ACOUSTIC DESIGN REVIEW

11 KINGS WAY, BURGESS HILL

Our Ref: 7738_001R_2-0_JE

Date: 28 November 2024

Figure 5-2: Ground floor plant layout

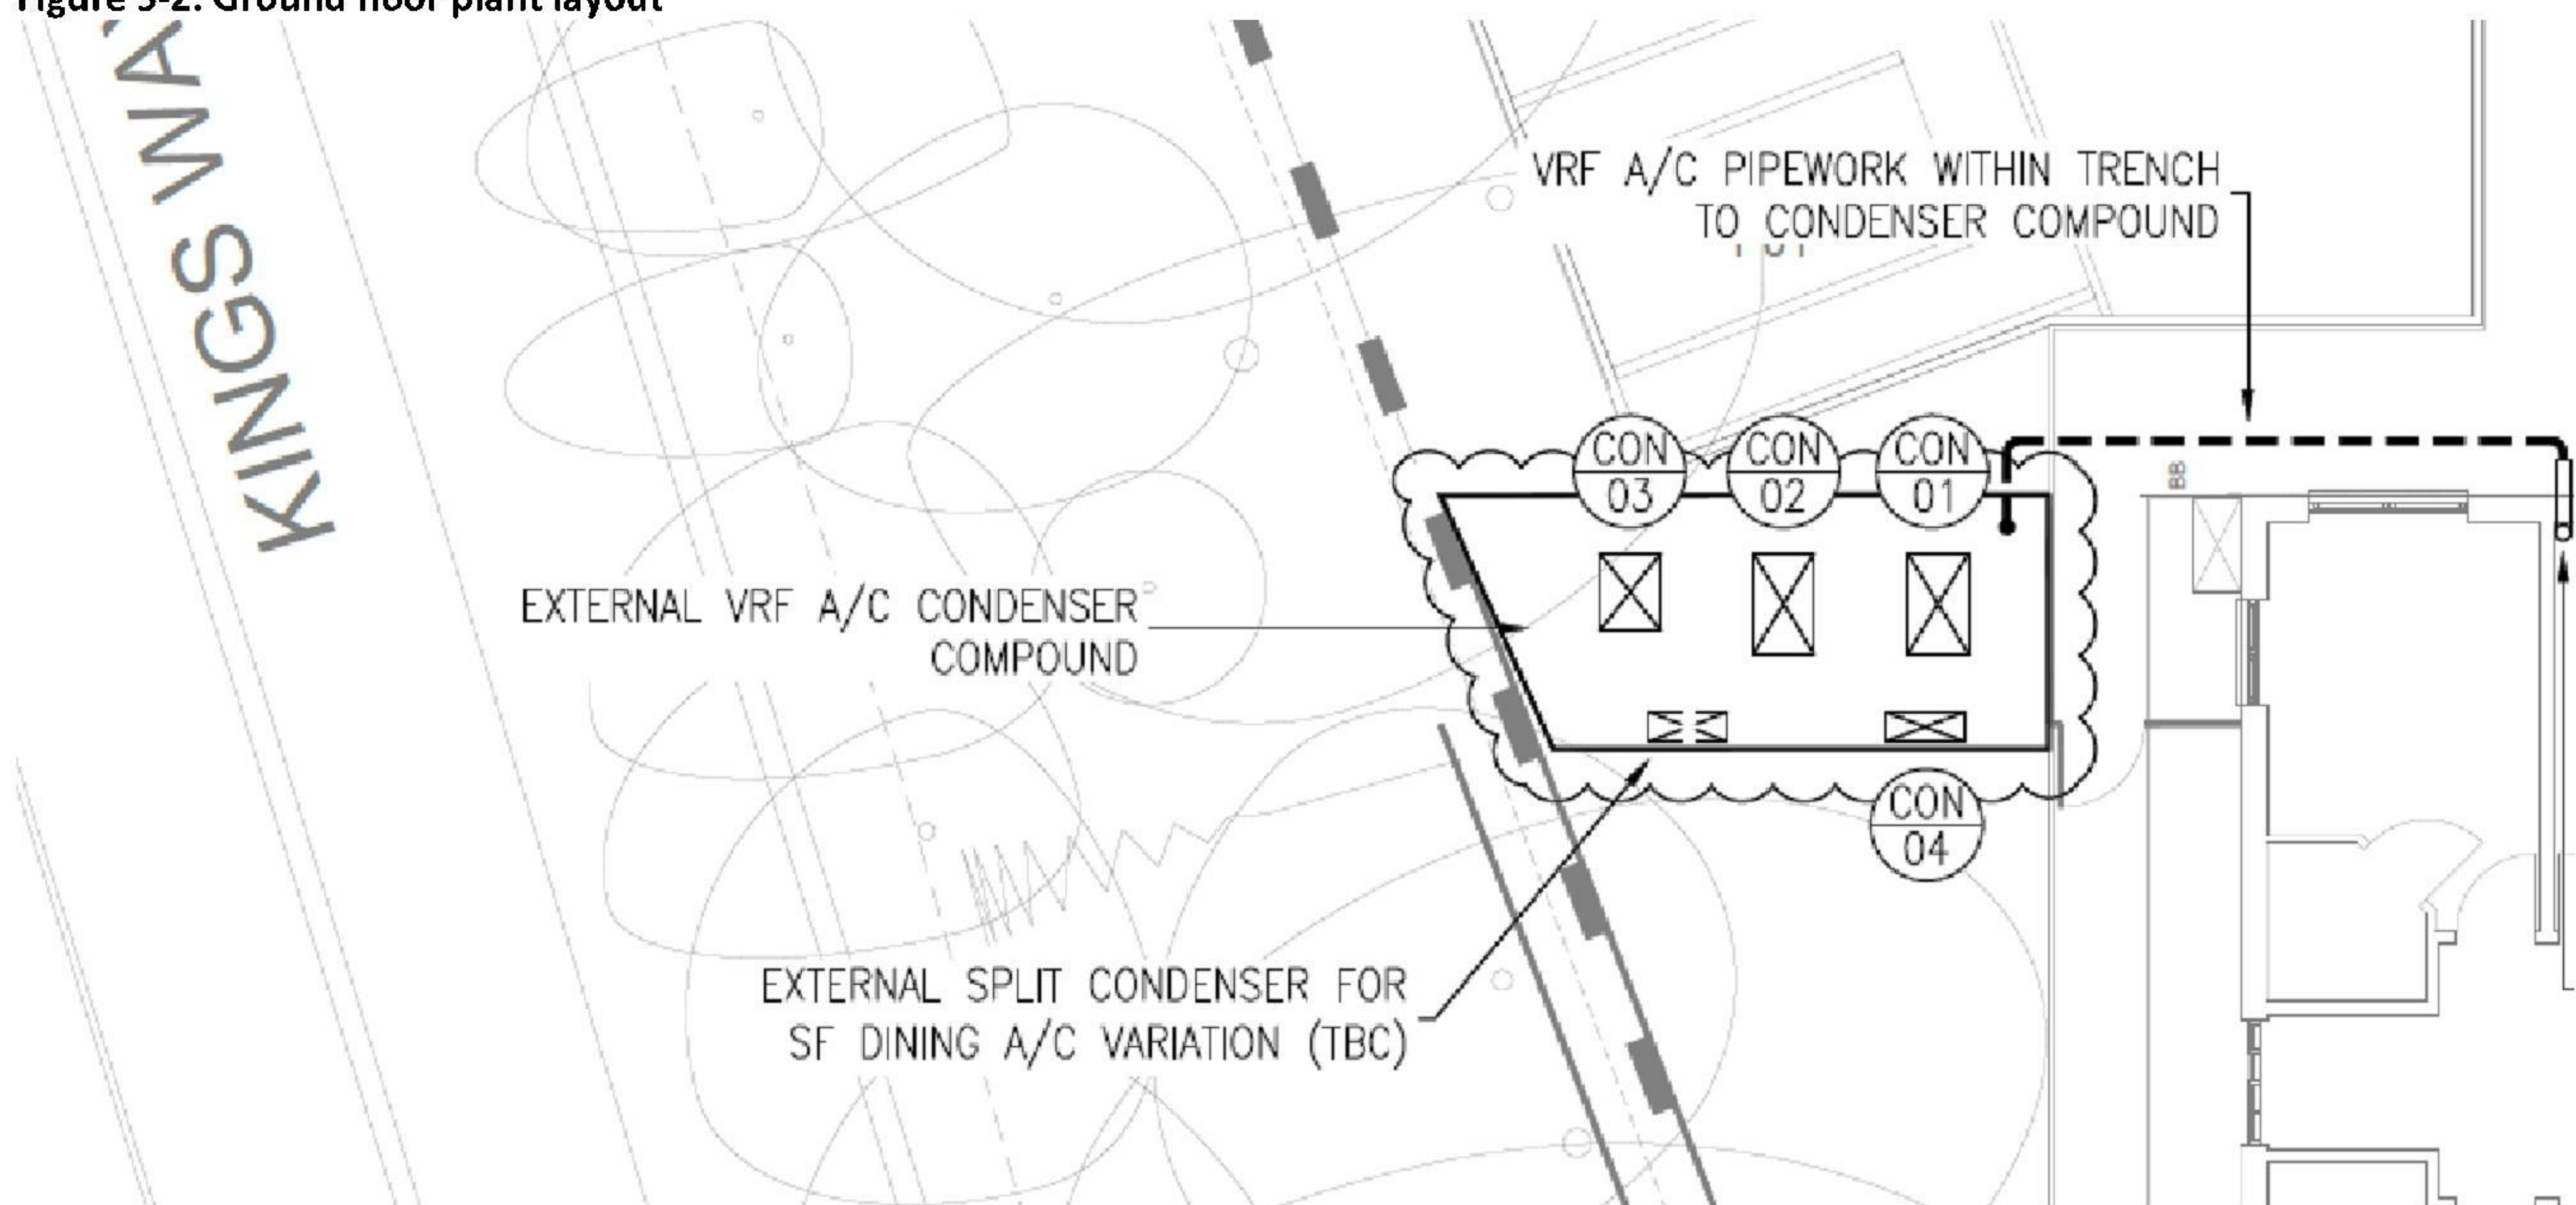
It is proposed that CON01 and CON02 will be housed within enclosures providing no less than 10 dB attenuation.

Enclosures should be selected to ensure that appropriate ventilation is provided to the units, otherwise increased noise levels may be experienced. The following manufacturers can supply and install these type of units.

Figure 5-3: Predicted specific sound level – Daytime Period

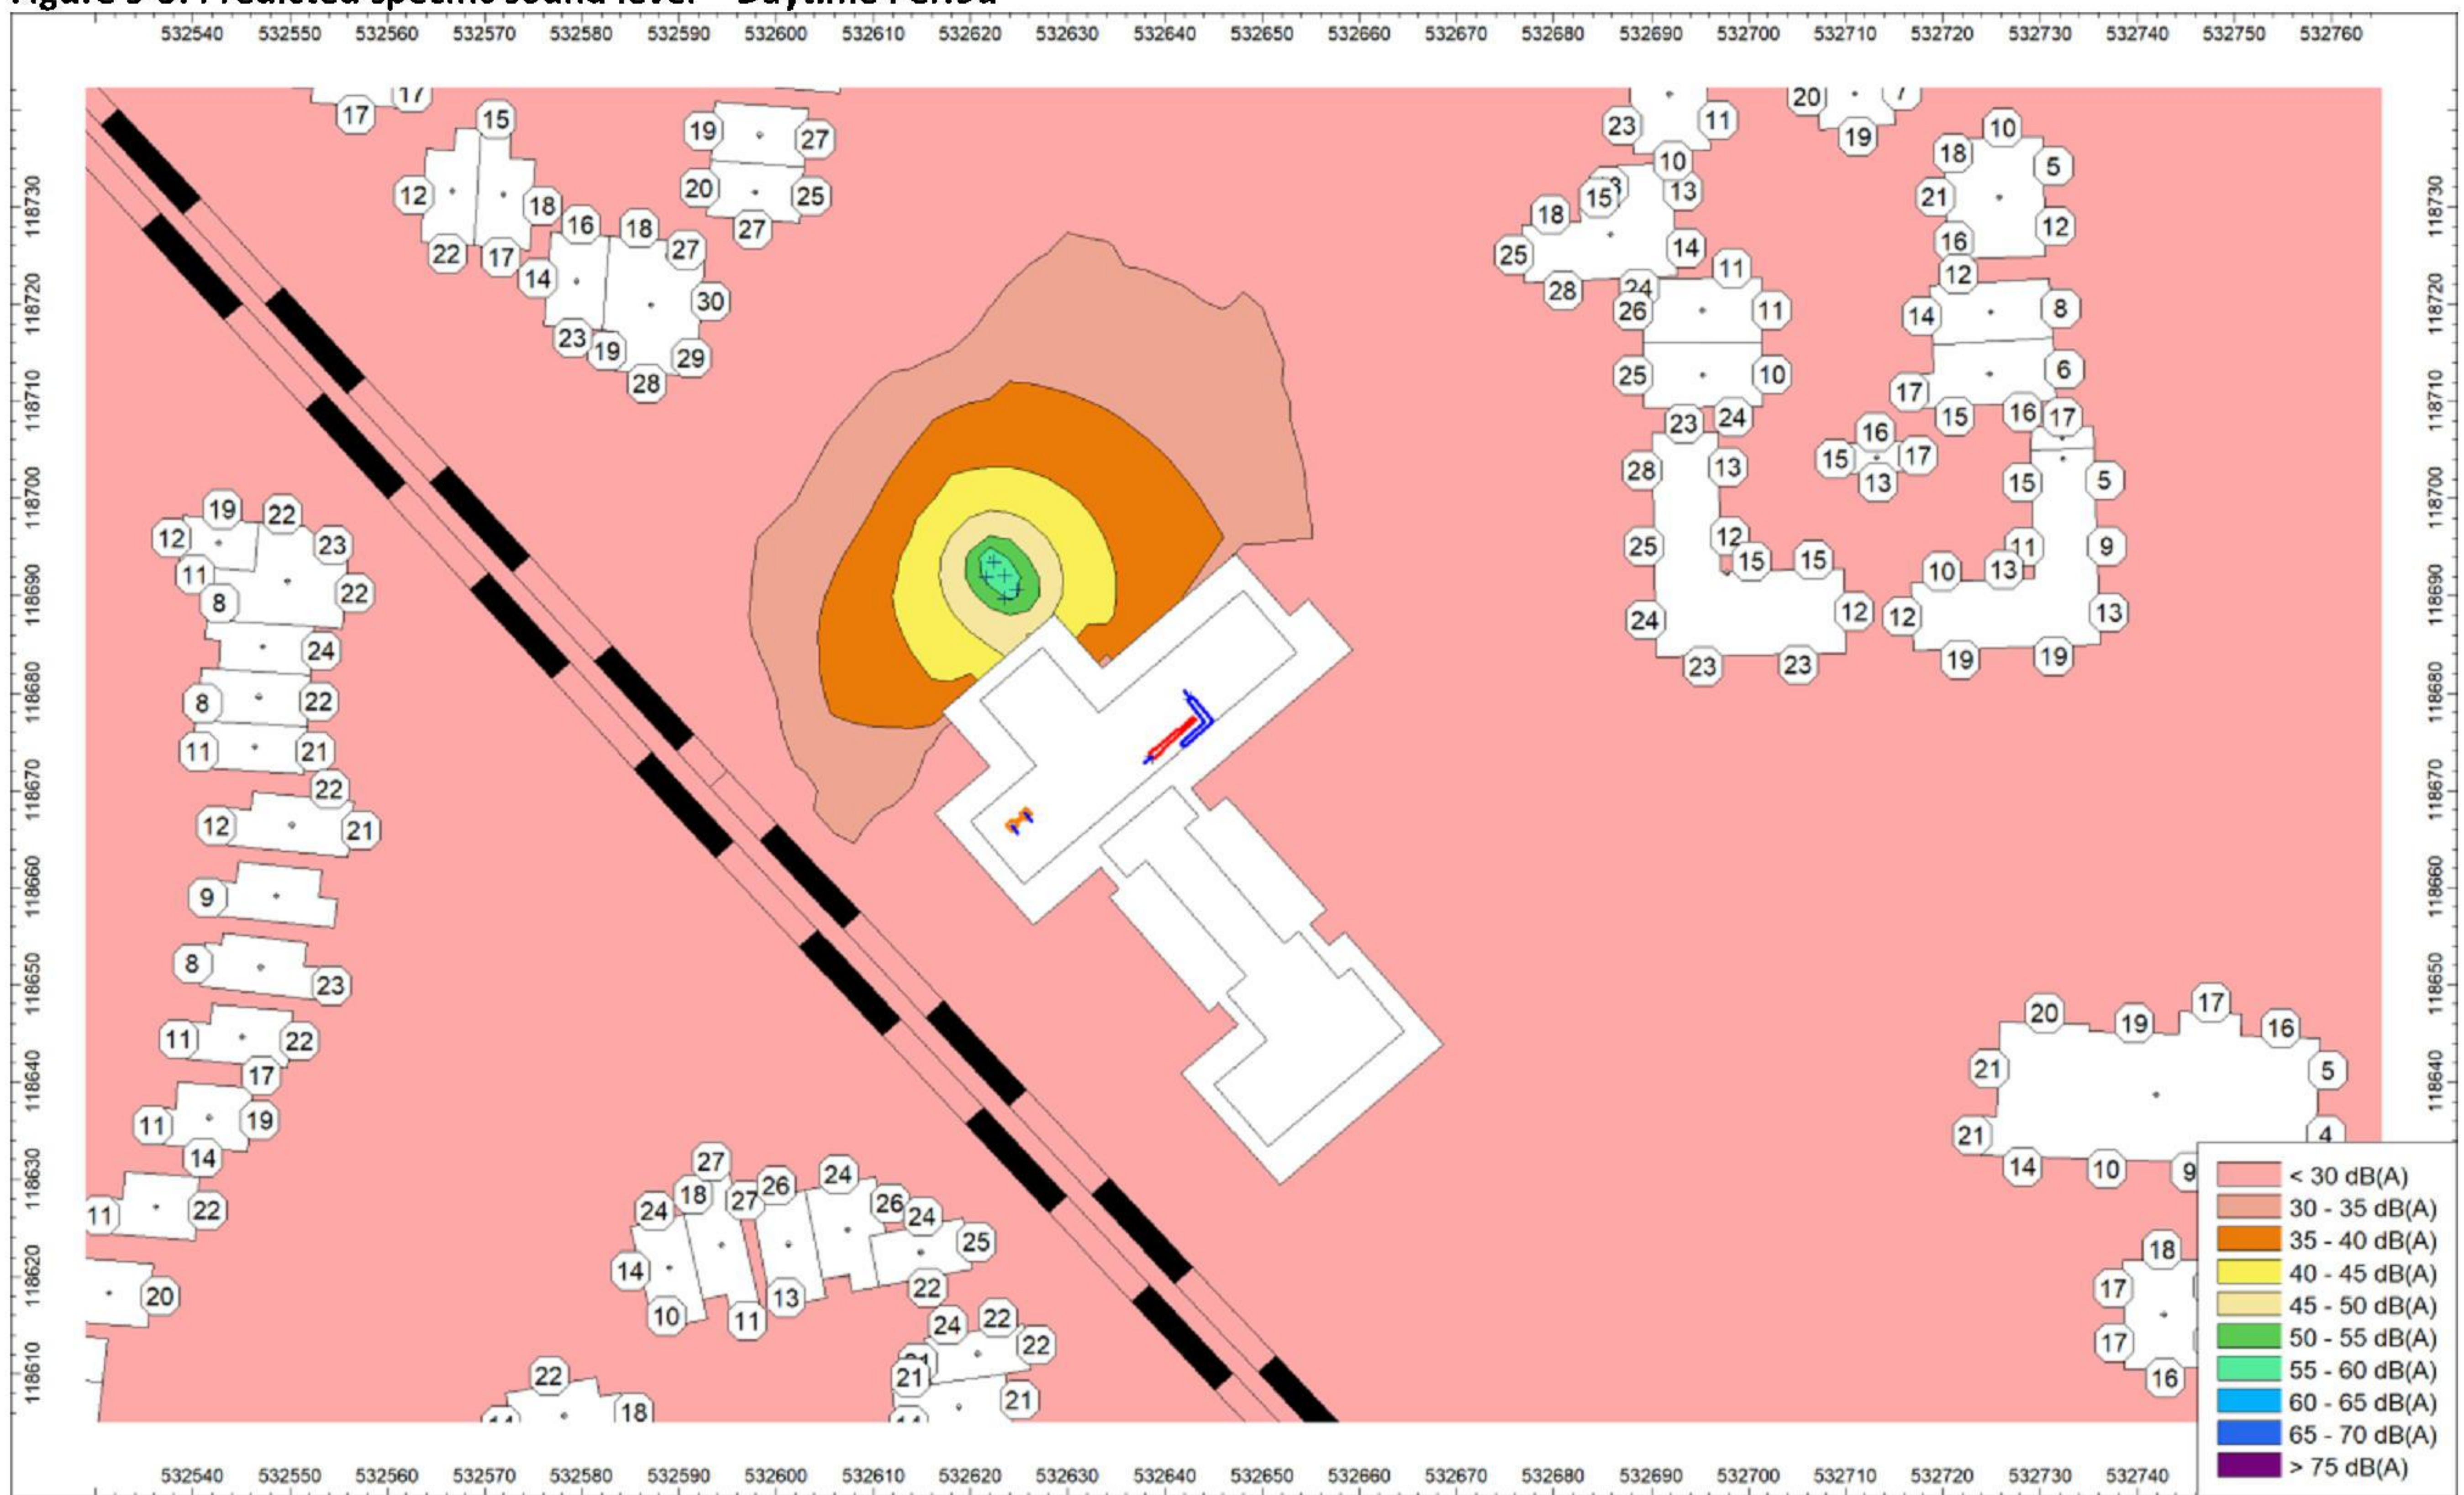
Description	Calculated Sound Pressure Level at Receiver Location (dBA)				
	NSR1	NSR2	NSR3	NSR4	NSR5
Maximum Predicted Specific Sound Level, $L_{Aeq,T}$	30 dB	28 dB	21 dB	27 dB	24 dB
Acoustic Penalties (Intermittency)	+3 dB	+0 dB [a]	+0 dB [a]	+0 dB [a]	+0 dB [a]
Rating Level, $L_{Ar, Tr}$	33 dB	28 dB	21 dB	27 dB	24 dB
Rating Level Criteria, $L_{Ar, Tr}$	33 dB	33 dB	33 dB	33 dB	33 dB
Excess of calculated Rating Level over Target Rating Level	+0 dB	-5 dB	-12 dB	-6 dB	-9 dB

The above assessments indicate that the predicted Plant Rating Level will not exceed the proposed criteria at any of the receptor locations during the daytime or night-time period. Furthermore, these predictions are considered to represent the worst-case operational periods. This results in a *Low Impact* in accordance with BS 4142 guidance. Therefore, no additional mitigation measures are required.

Figure 5-4: Predicted specific sound level – Night-time Period

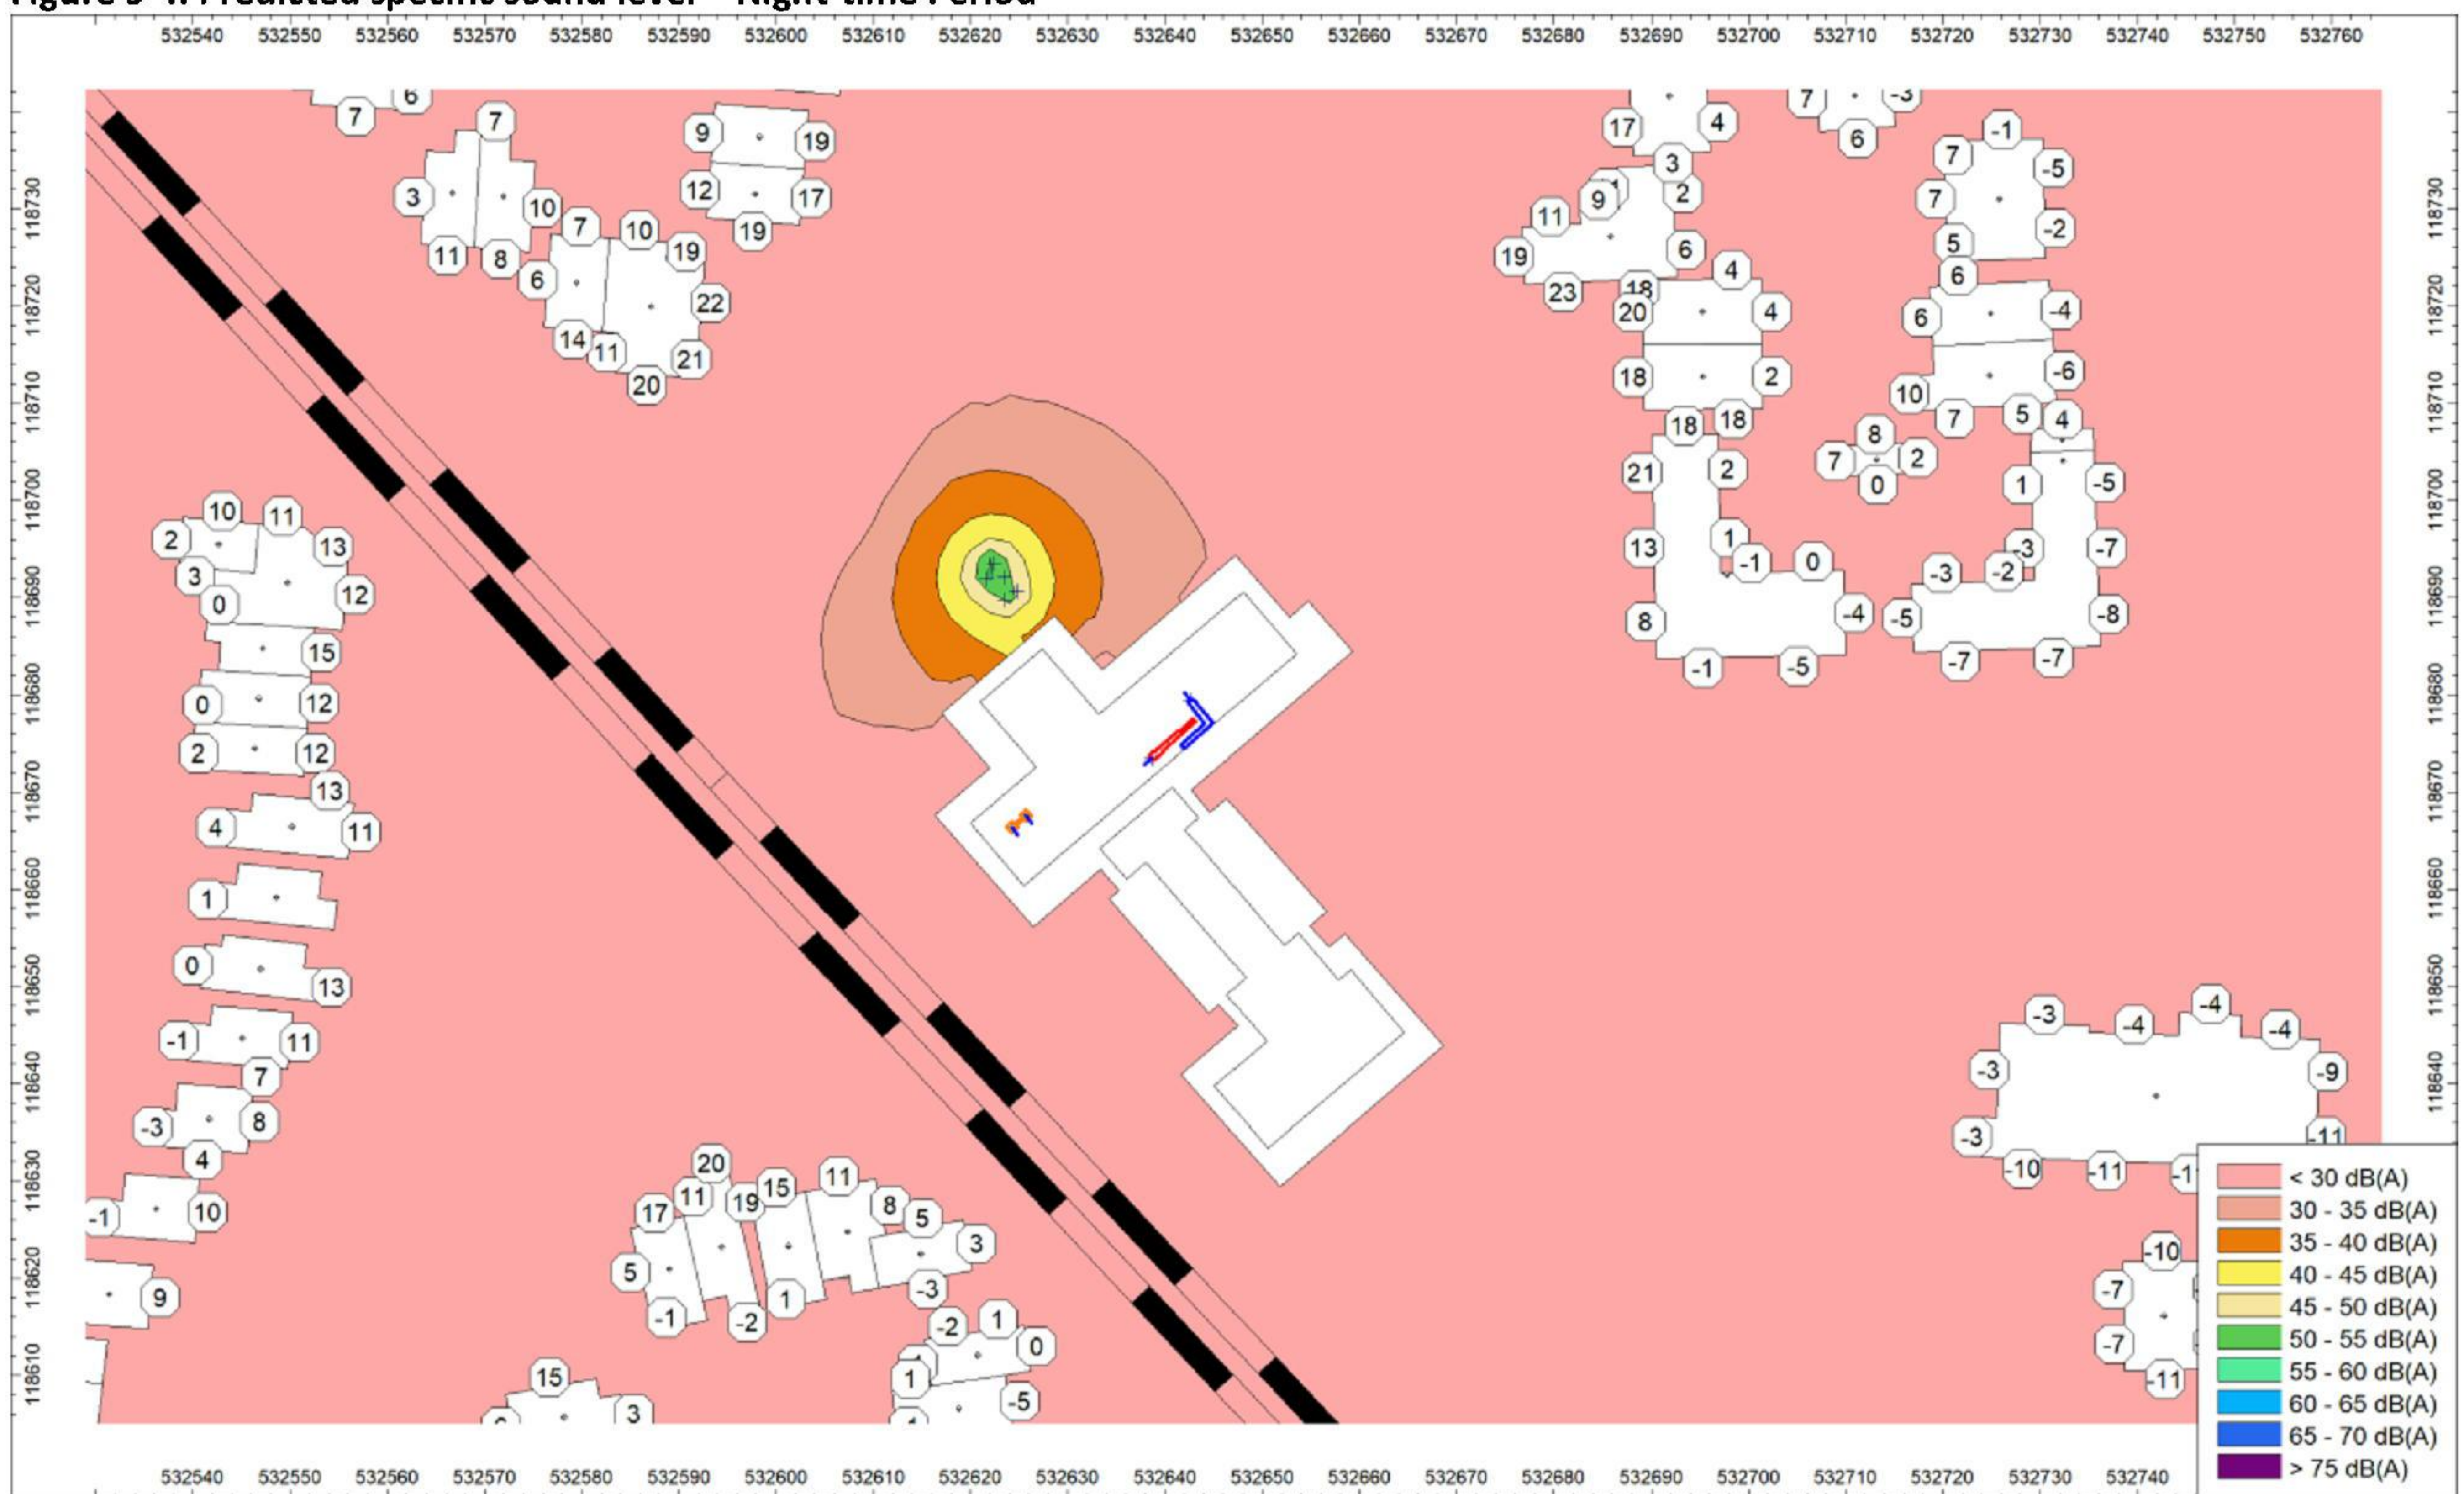
Description	Calculated Sound Pressure Level at Receiver Location (dBA)				
	NSR1	NSR2	NSR3	NSR4	NSR5
Maximum Predicted Specific Sound Level, $L_{Aeq,T}$	22 dB	23 dB	0 dB	20 dB	15 dB
Acoustic Penalties (Intermittency)	+3 dB	+3 dB	0 dB [a]	+3 dB	0 dB [a]
Rating Level, $L_{Ar, Tr}$	25 dB	26 dB	0 dB	23 dB	15 dB
Rating Level Criteria, $L_{Ar, Tr}$	30 dB	30 dB	30 dB	30 dB	30 dB
Excess of calculated Rating Level over Target Rating Level	-5 dB	-6 dB	-30 dB	-7 dB	-15 dB
